SUBMITTAL OF HANFORD FACILITY RESOURCE CONSERVATION AND RECOVERY ACT (RCRA) PERMIT MODIFICATION NOTIFICATION FORM 24590-HLW-PCN-ENV-06-013

**Hanford Facility RCRA Permit Modification Notification  
Form 24590-HLW-PCN-ENV-06-013**

Page 2 of 3: Hanford Facility RCRA Permit, Part III, Operating Unit 10, Waste Treatment and Immobilization Plant  
Update HLW Vitrification Building Piping and Instrumentation Diagrams (P&IDs) for the HLW Canister  
Decontamination Handling System (HDH-VSL-00001, HDH-VSL-00002, HDH-VSL-00003 and HDH-VSL-  
00004) in Appendix 10.2 of the Dangerous Waste Permit.

**24590-HLW-M6-HDH-P20001**

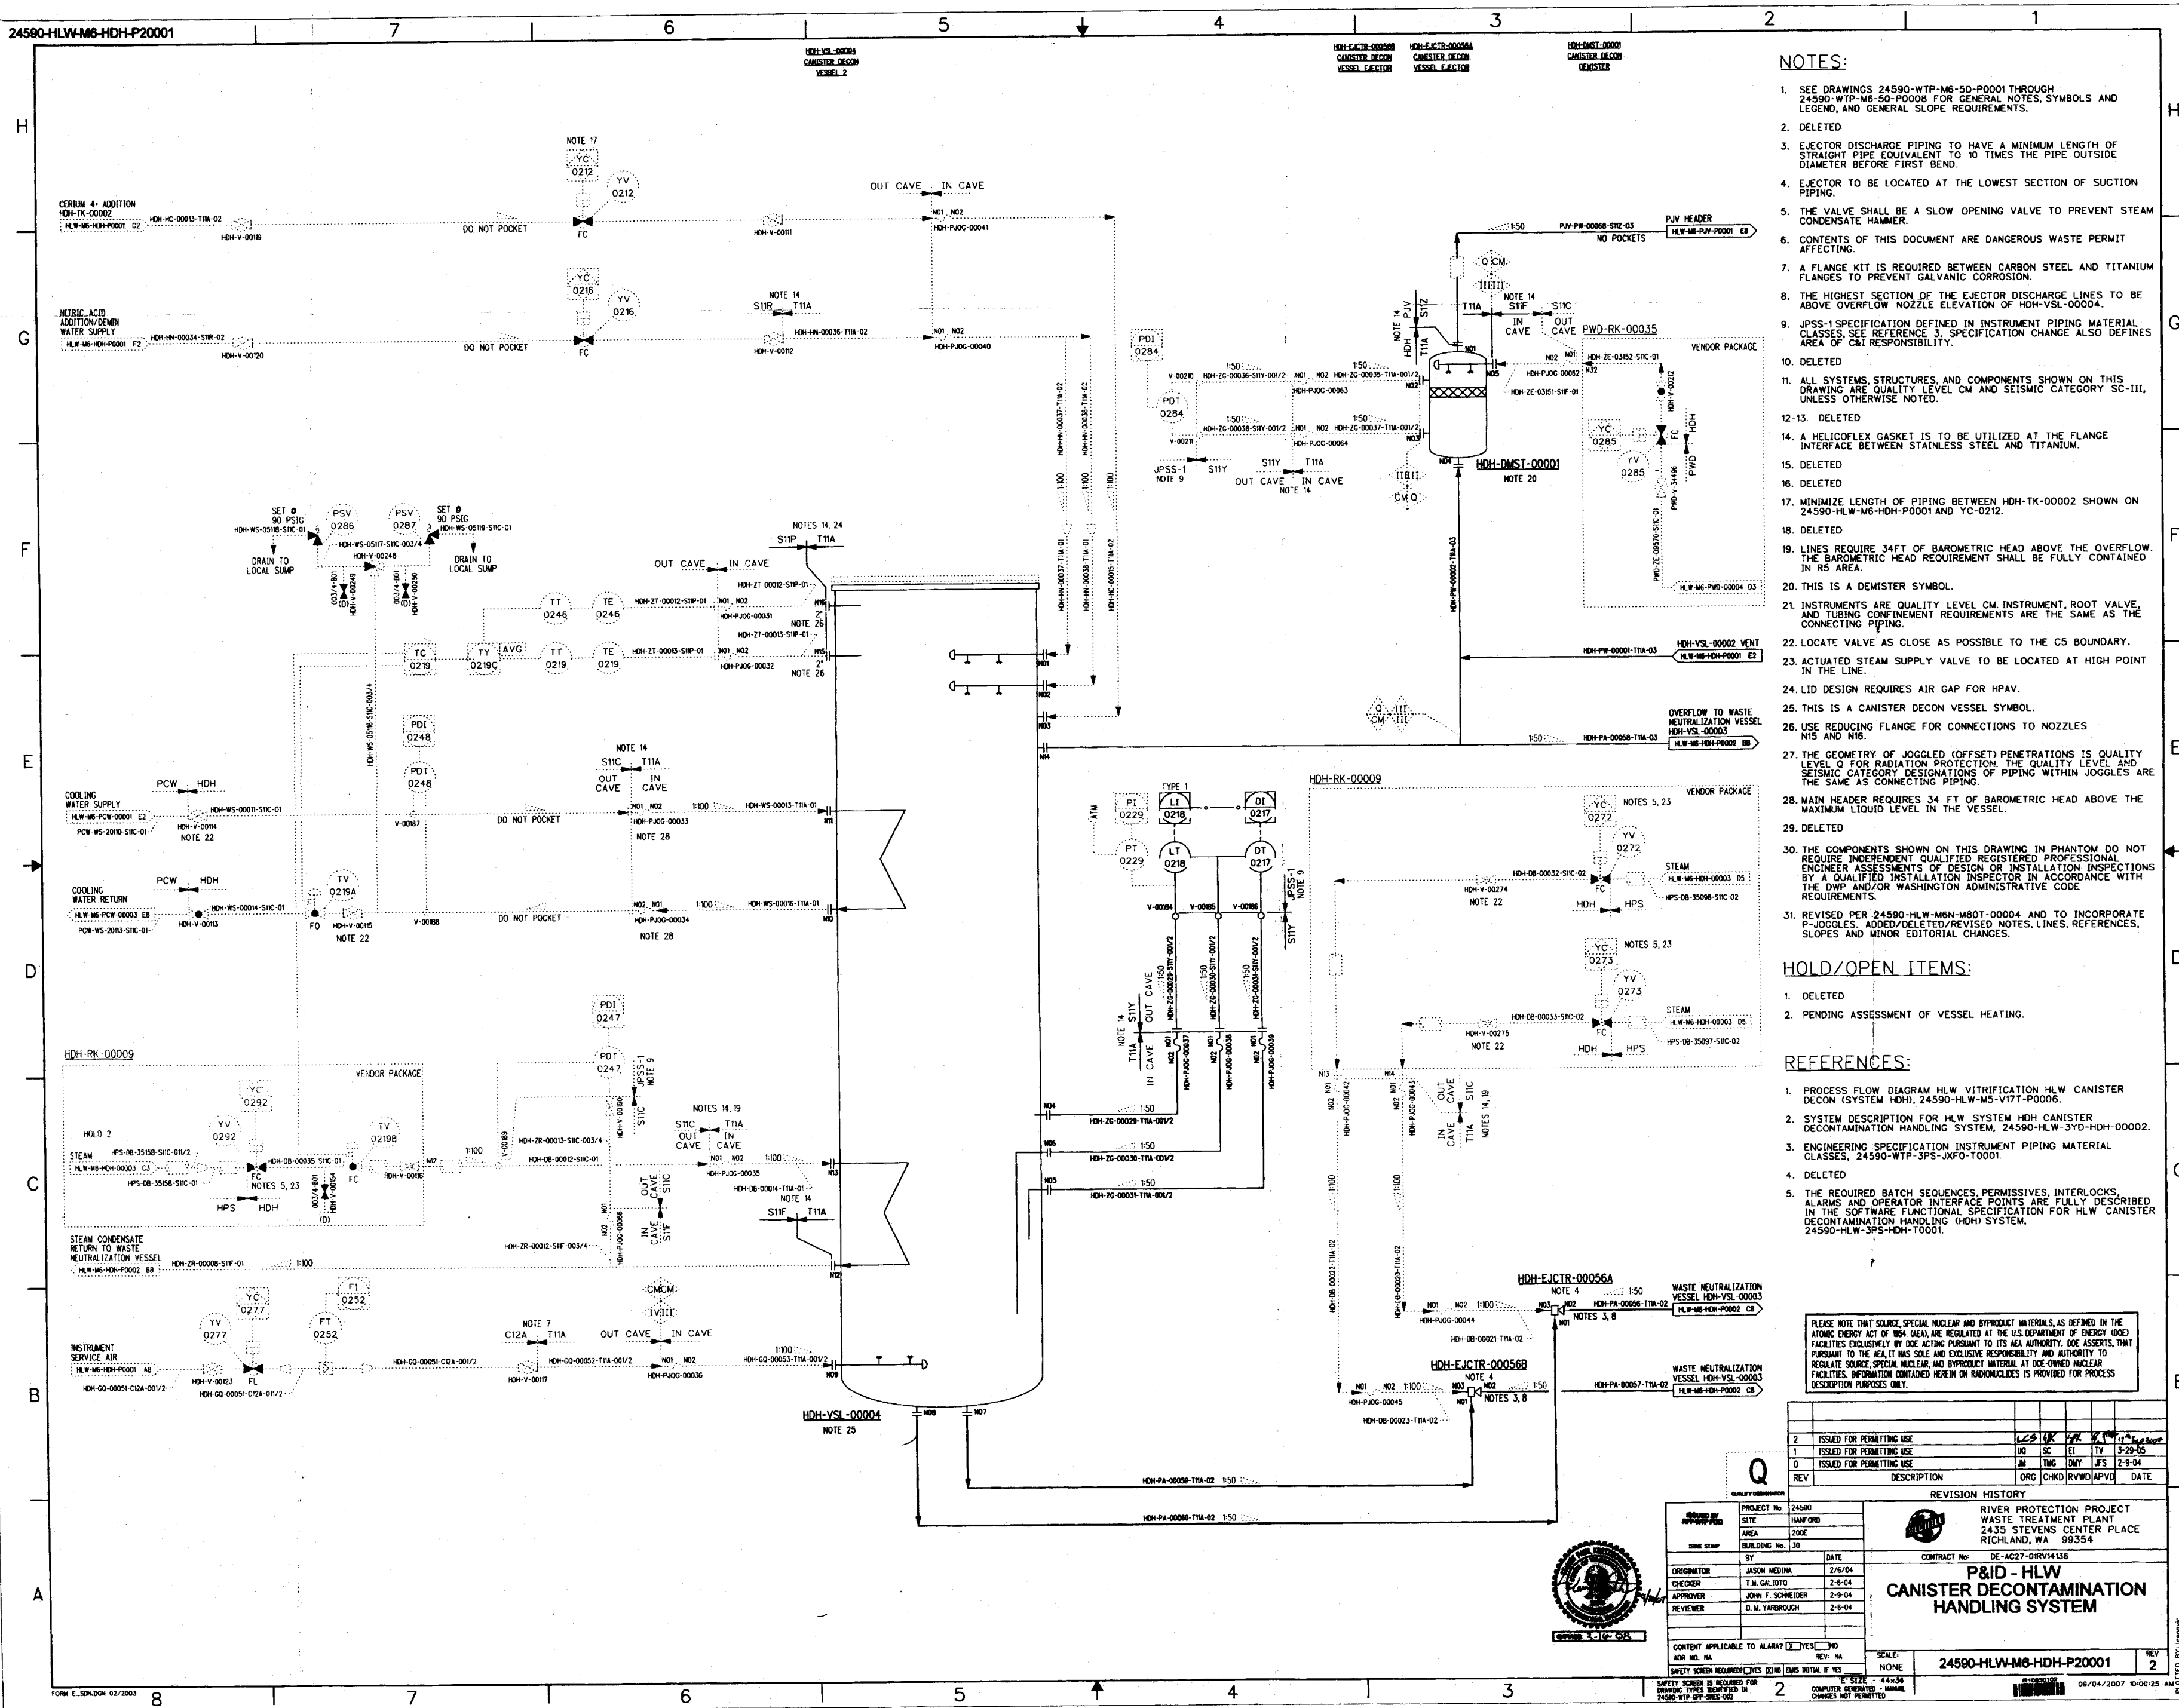
Specific changes to this P&ID are provided on note 31.

- Incorporated updates to design
- Revised slope notation to specific lines
- Added, revised, and deleted notes, holds, and references
- Revised various off-sheet connectors
- Revised through wall penetration designations from wall boxes to p-joggles
- Combined overflow line vents (HDH-VSL-00002 and HDH-VSL-00004) and routed to PJV Header through demister (HDH-DMST-00001)
- Added demister HDH-DMST-00001 (coordinates G3)
- Revised and added various quality/seismic identifiers
- Revised and added line identification numbers.

31. REVISED PER 24590-HLV-M6-HDH-P0004 AND TO INCORPORATE P&ID CHANGES, ADDED/DELETED/REVISED NOTES, LINES, REFERENCES, SLOPES AND MINOR EDITORIAL CHANGES.
